Sling Aircraft (Pty) Ltd
Registration no 2002/022837/07
Approved Maintenance Organisation AMO1264
Manufacturing Organisation M677

SERVICE BULLETIN

#0020 Revision 1

SUBJECT: Eyebolt inspection and conditional replacement

Figure 3: Type 3 Eyebolt

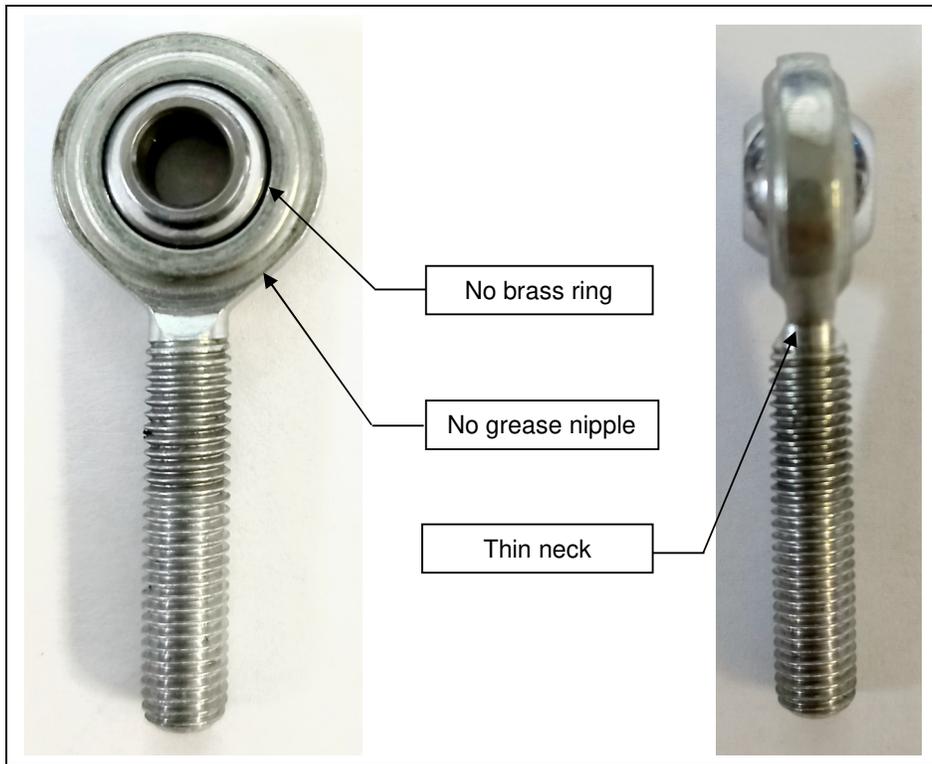
All aircraft will need to be inspected during the next MPI (or annual inspection, whichever is reached first). If it is found that *type 3* or *type 4* eyebolts have been supplied and used, they must be replaced with either *type 1* or *type 2*. Any kits still under construction will need to be inspected and required replacements must be made before the aircraft's first flight.

As seen below, the main difference between *type 3 and 4*, and the other two eyebolt types is the brass ring and shape of the neck of the eyebolt.

All eyebolts must be inspected at the aircraft's next MPI or annual inspection. This is applicable to aircraft that are already flying. Any aircraft still under construction must be inspected prior to its first flight. The various eyebolt types can be seen in Figure 1, Figure 2, Figure 3 and Figure 4 respectively. If *type 3 or 4* eyebolts have been supplied, they must be replaced.

Figure 5: Rudder and Nose Wheel Controls

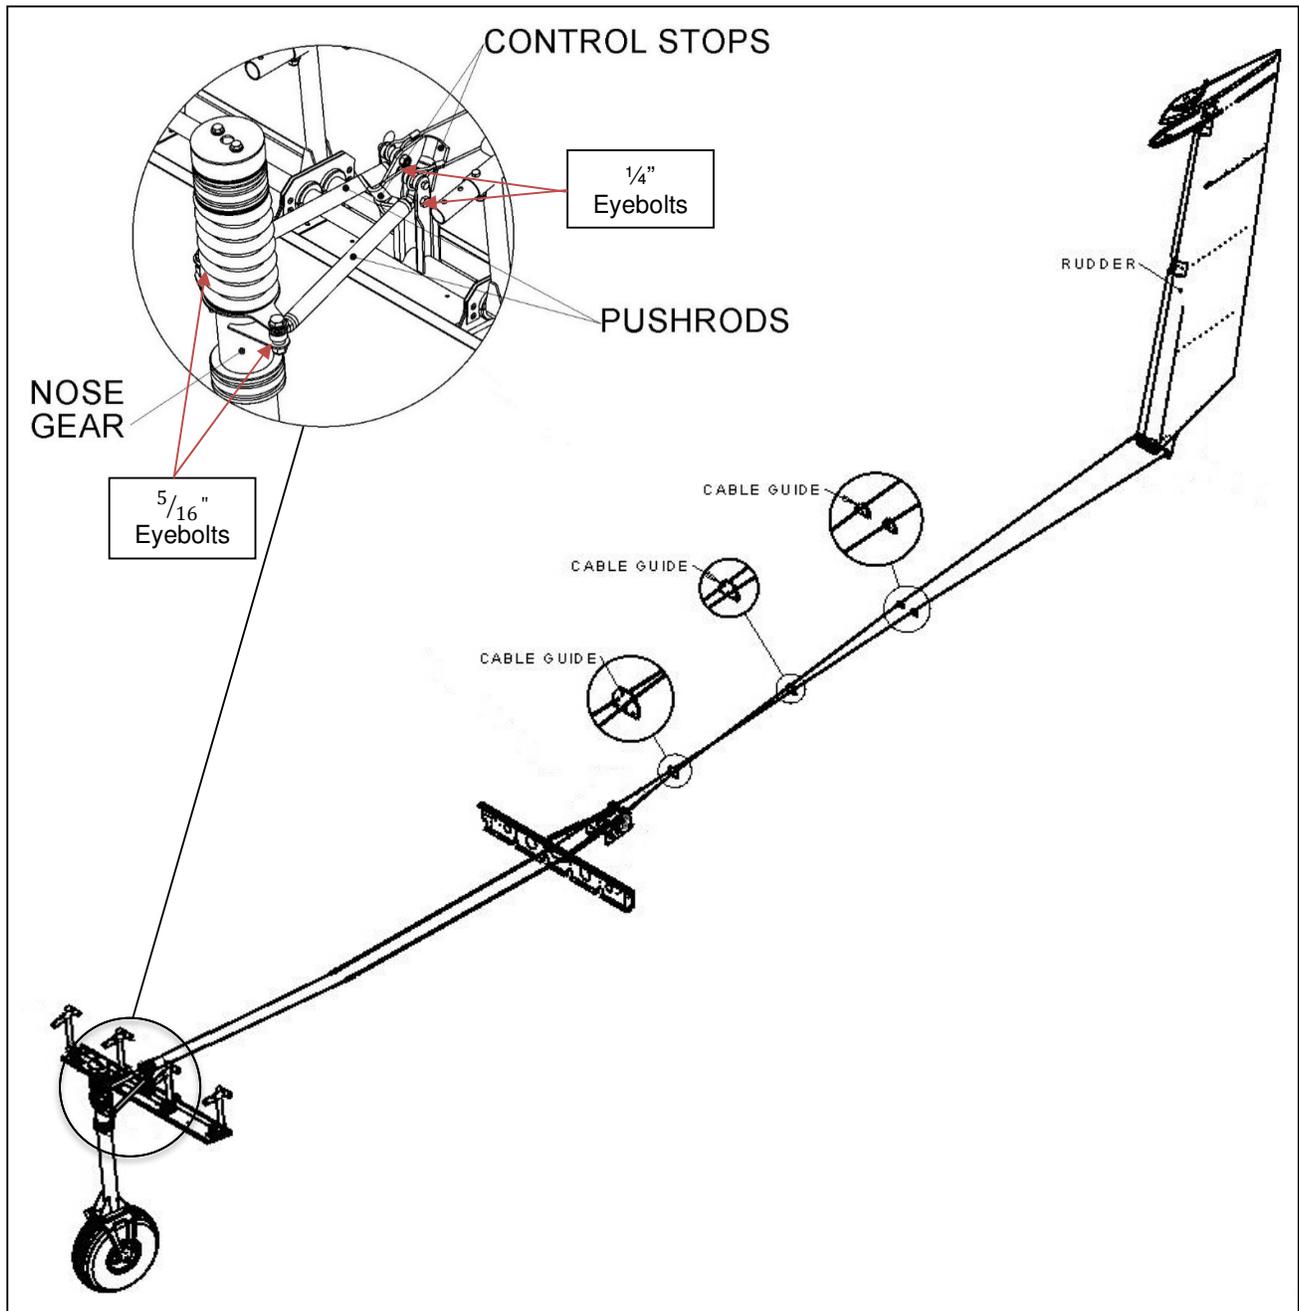
The eyebolts used in the rudder and nose wheel control arm assembly can be seen in Figure 5. The eyebolts need to be inspected and replaced where *noncompliant* eyebolts have been installed.

Step 4. Install new 5/16" eyebolts, either a *type 1* or *type 2* eyebolt, on the pushrods. To do this, reverse the procedure performed in Step 1.

Step 5. Remove the 1/4" eyebolts, these are located on the rudder pedal assembly as shown in Figure 5, and can be accessed from inside the cabin. By referring to Figure 6, remove the AN4 locknut and AN4 bolt. The 1/4" eyebolt can now be uninstalled from the pushrod.

Step 6. Replace the 1/4" eyebolts with the correct type (either *type 1* or *type 2* may be used), reinstall them onto the pushrod and connect them to the rudder pedal assembly once more. Refer to Figure 6 for the way in which the components fit together.

Figure 7: Aileron Controls

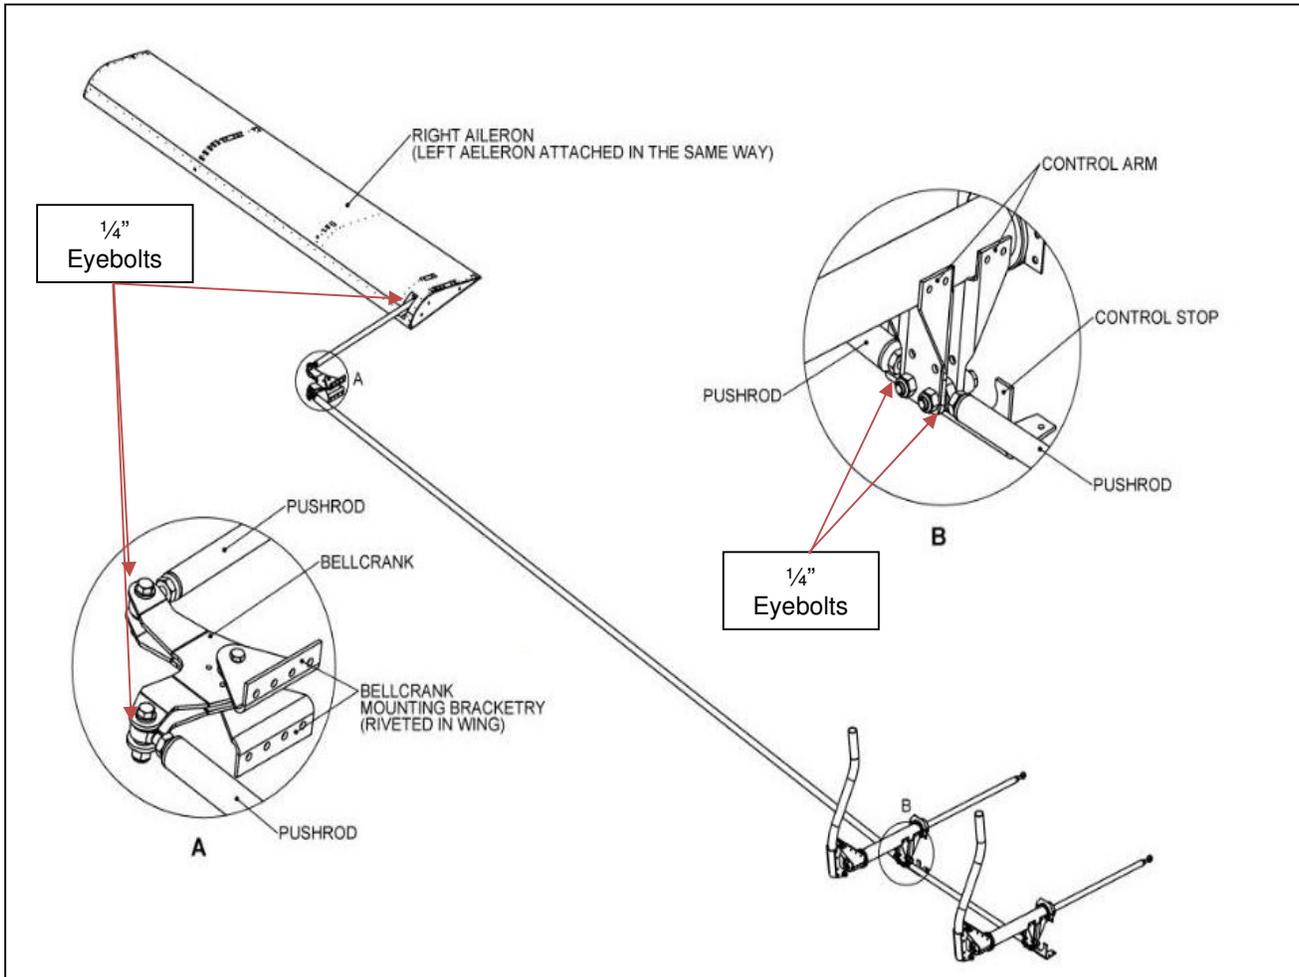
The eyebolts used in the aileron control assembly can be seen in Figure 7. These can be inspected using the inspection hatches located on the wing. Due to symmetry only one aileron has been shown. The same eyebolts will be found on the other side of the aircraft. The eyebolts need to be inspected and replaced where *noncompliant* eyebolts have been installed.

- Step 2. Ensure both eyebolts that are connected to the control arm in Detail B are replaced, with either a *type 1* or *type 2* eyebolt, if *noncompliant* eyebolts have been used.
- Step 3. Reverse the procedure in Step 1 to reinstall the eyebolt assembly.
- Step 4. To replace the eyebolts seen in Detail C of Figure 8, remove the AN4 locknut (13) and bolt (16). The eyebolt should now be uninstalled from the pushrod (5). A *type 1* or *type 2* eyebolt should then be installed on the pushrod.

Figure 9: Aileron bell-crank assembly

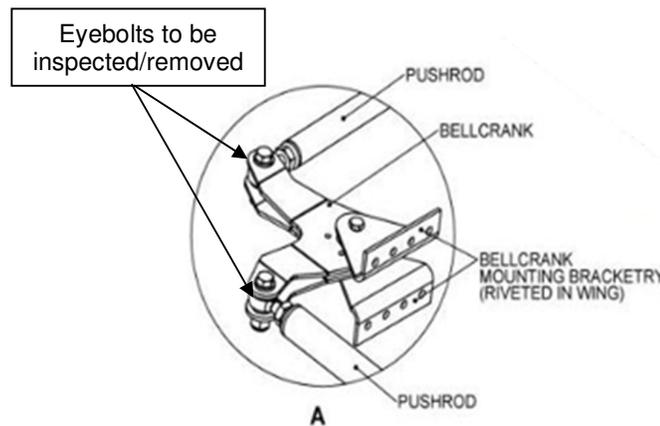
- Step 9. Refer to Figure 9 and remove the AN4 locknuts and bolts.
- Step 10. The eyebolts can now be removed and replaced with either *type 1* or *type 2* eyebolts, if required.
- Step 11. Reinstall the eyebolts to the bell-crank assembly, by reversing the procedure in Step 9 . Refer to the installation procedure in the manual shown in the table below for component placement:

Figure 10: Aileron leading edge eyebolt assembly

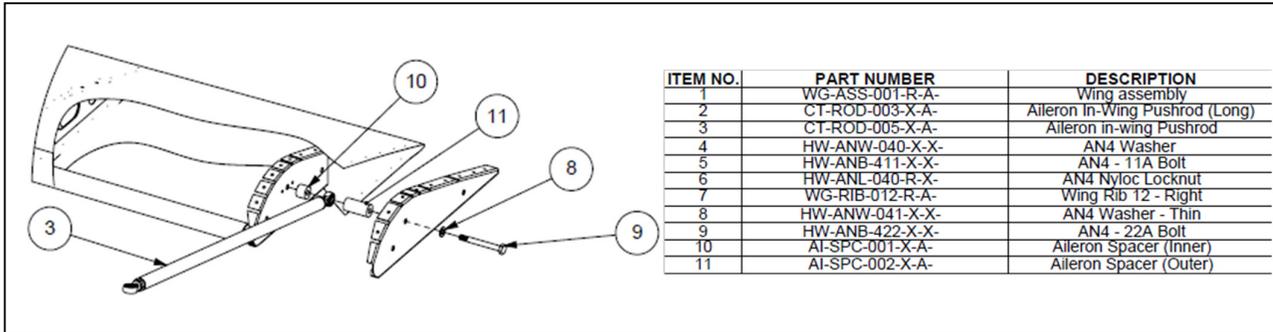
Step 13. For the eyebolts located at the ailerons leading edge, remove the AN4 bolt (9) shown in Figure 10. To access this bolt, you will need to drop the flap. To do this follow steps 1 and 2 *only*, of the flap removal procedure (Option1). This procedure can be found in the applicable MAM shown in the table below. Remember to support the flap during this step as it may drop.

- Step 14. After bolt (9) has been removed, the eyebolt can be replaced with either a *type 1* or *type 2* eyebolt. Reconnect it to the aileron and pushrod (3), as shown in Figure 10. Support the aileron during this step as it may drop once the eyebolt has been removed.
- Step 15. Reattach the flap by reversing the procedure followed in Step 13.
- Step 16. Repeat Step 9 to Step 15 to remove the eyebolts used in the aileron control assembly on the other side of the aircraft.
- Step 17. You will need to adjust the ailerons once the new eyebolts have been installed, to ensure correct aileron deflection. To do this, follow the instructions in the applicable MAM shown in the table below:

Figure 11: Aileron Controls

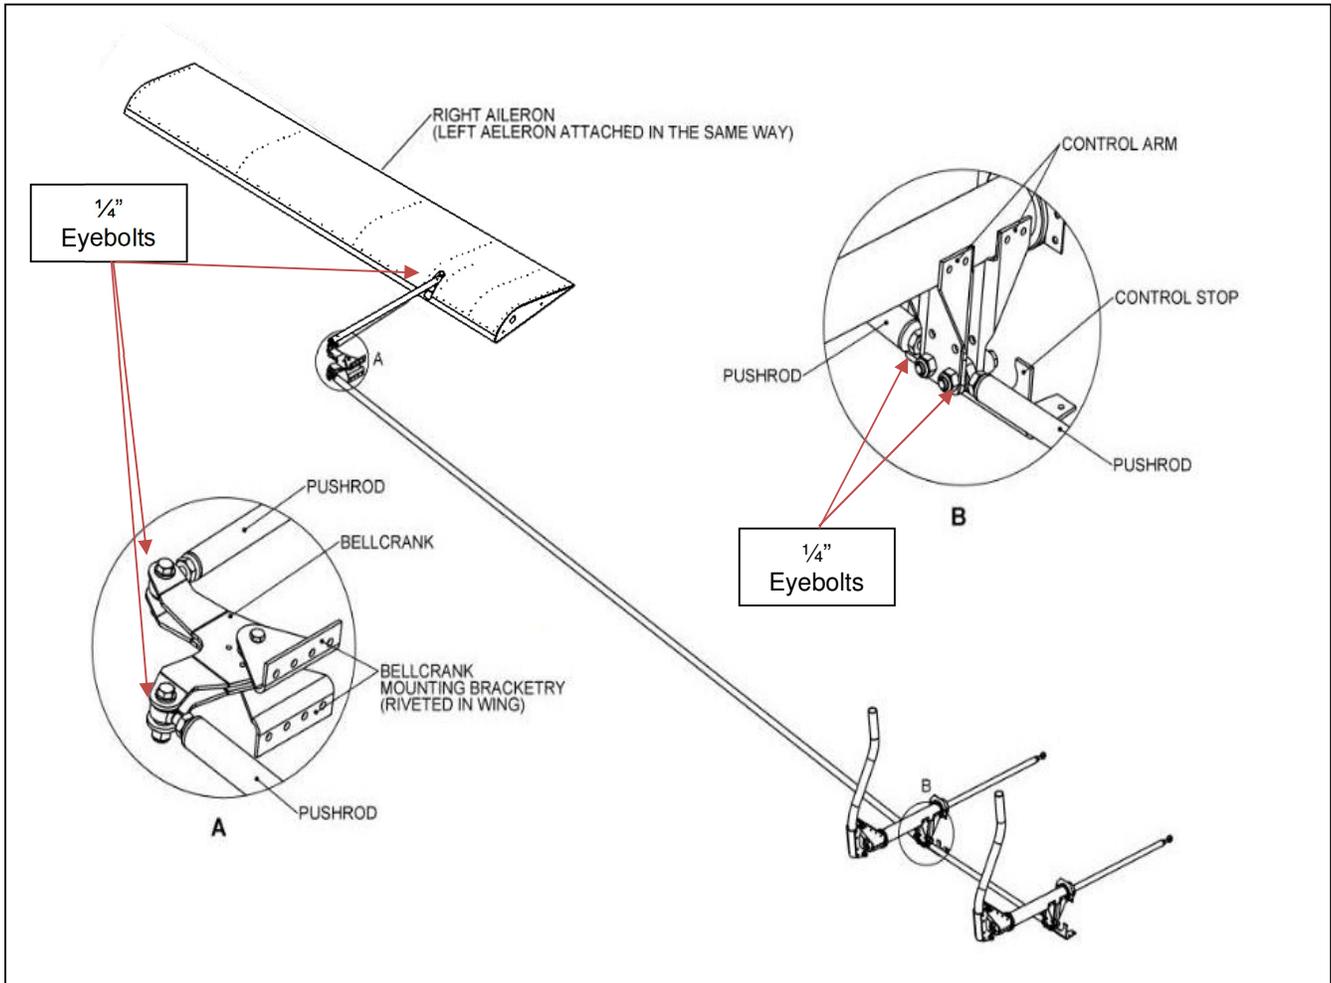
The eyebolts used in the aileron control assembly can be seen in Figure 11. These can be inspected using the inspection hatches located on the wing. Due to symmetry only one aileron has been shown. The same eyebolts will be found on the other side of the aircraft. The eyebolts need to be inspected and replaced where *noncompliant* eyebolts have been installed.

- Step 2. A *type 1* or *type 2* eyebolt should then be installed in place of the *noncompliant* eyebolt, if required. Ensure both eyebolts that are connected to the control arm in Detail B are replaced, if *noncompliant* eyebolts have been used.
- Step 3. Reverse the procedure in Step 1 to reinstall the eyebolt assembly. Do not replace the seats and control covers that were removed in Step 1 until the required eyebolts shown in Section 3.2.6 have been inspected and replaced, if required.

Figure 12: Eyebolt assembly, Detail C

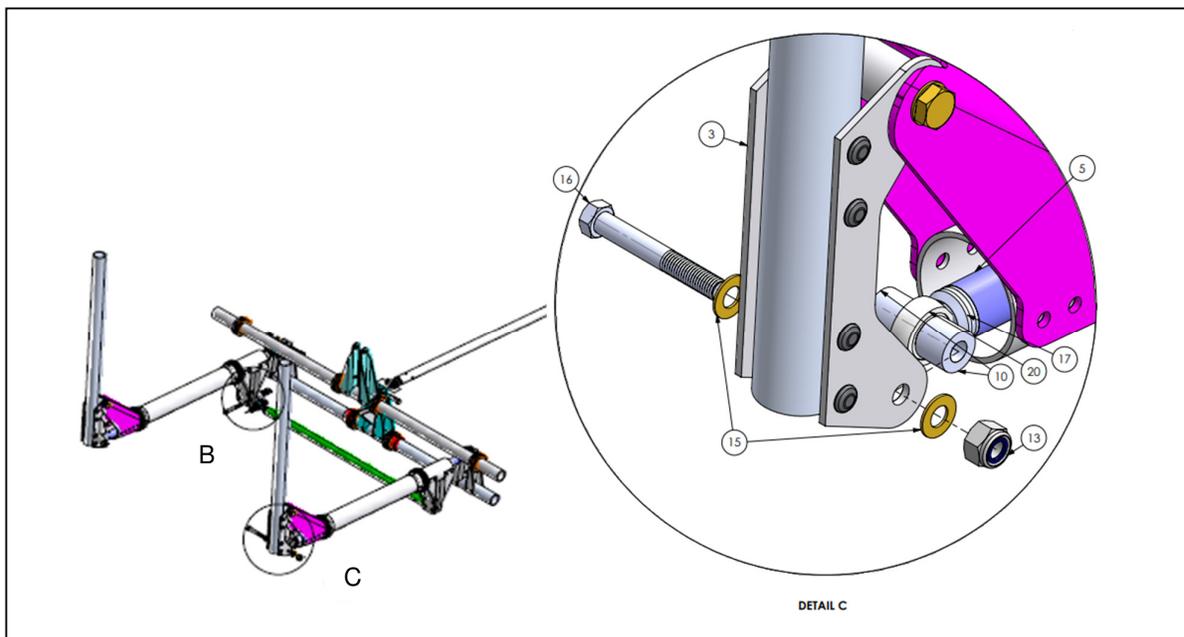
- Step 4. To replace the eyebolts seen in Detail C of Figure 12, remove the AN4 locknut (13) and bolt (16). The eyebolt should then be uninstalled from the pushrod (5). A *type 1* or *type 2* eyebolt should then be installed on the pushrod.

- Step 5. Reassemble the eyebolt assembly by reversing the procedure in Step 4, refer to Figure 12 for component placement.
- Step 6. The eyebolts used in the aileron bell-crank also need to be inspected and replaced if *noncompliant* eyebolts have been installed. These must be replaced with either *type 1* or *type 2* eyebolts. Remove the outboard inspection hatches on both wings, to expose the bell-cranks.

Figure 13: Aileron bell-crank assembly

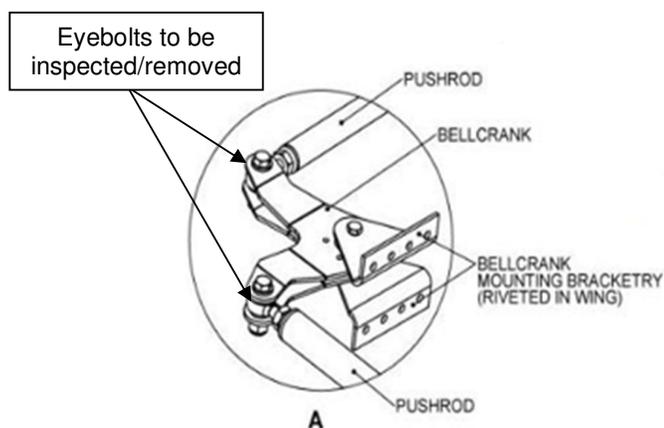
- Step 7. Refer to Figure 13 and remove the AN4 locknuts and bolts.
- Step 8. The eyebolts can now be removed and replaced with either *type 1* or *type 2* eyebolts, if required.

Figure 14: Aileron leading edge eyebolt assembly

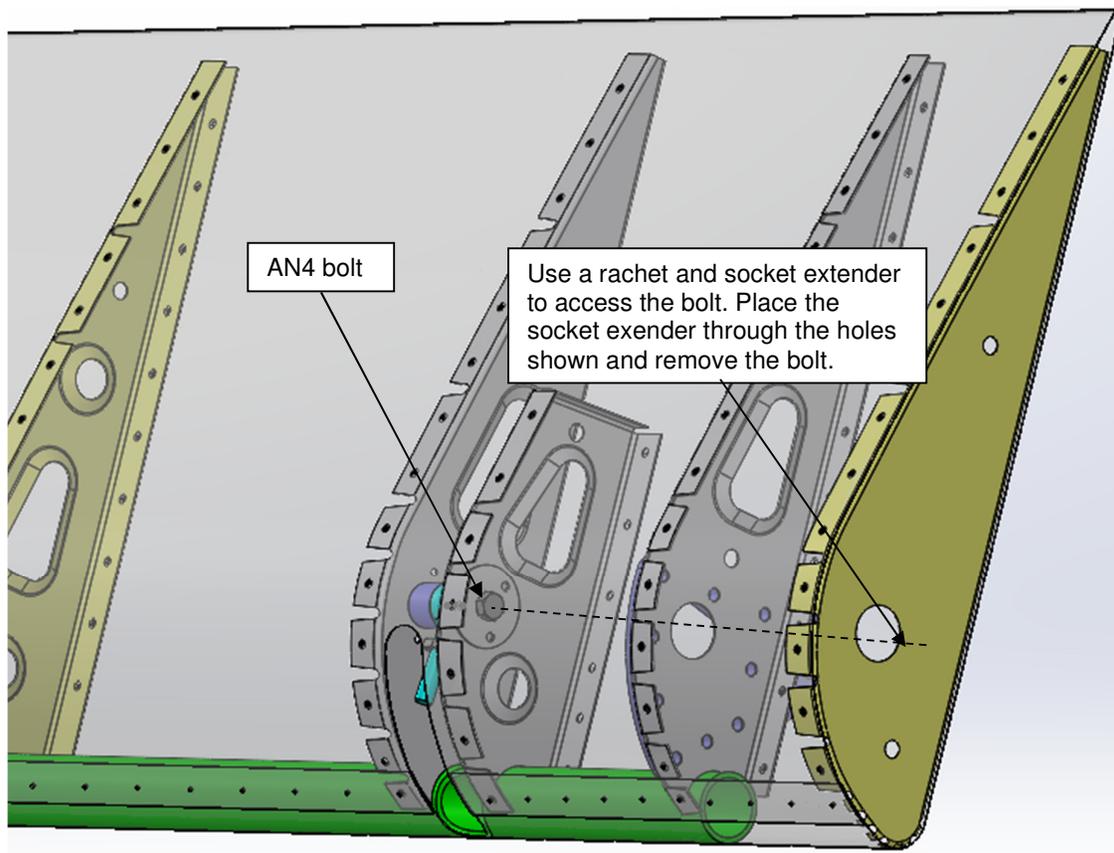
Step 11. For the eyebolts located at the ailerons leading edge, remove the AN4 bolt (9) shown in Figure 14. To access this bolt, you will need to drop the flap. To do this follow steps 1 and 2 *only*, of the Flap removal procedure (Option1). This procedure can be found in Section 4.1.3.2 of manual DC-MAM-001-X-F. Remember to support the aileron and flap during this step as they may drop.

Figure 15

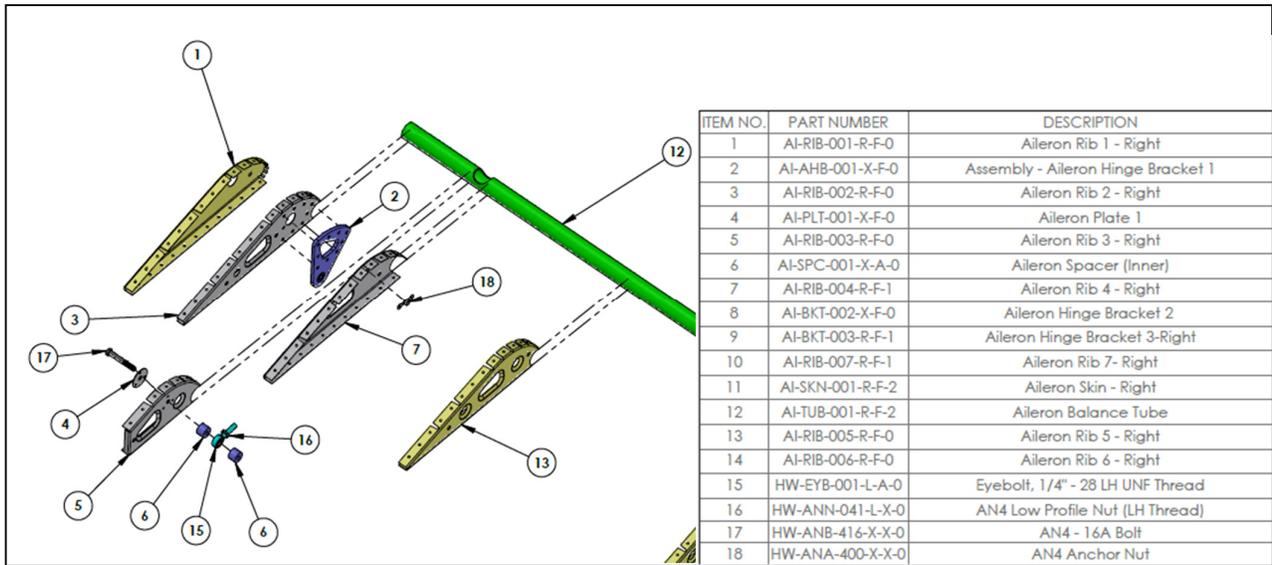
Step 12. After the bolt has been removed, the eyebolt can be replaced with either a *type 1* or *type 2* eyebolt. It should then be reconnected to the aileron and pushrod, as shown in Figure 15.
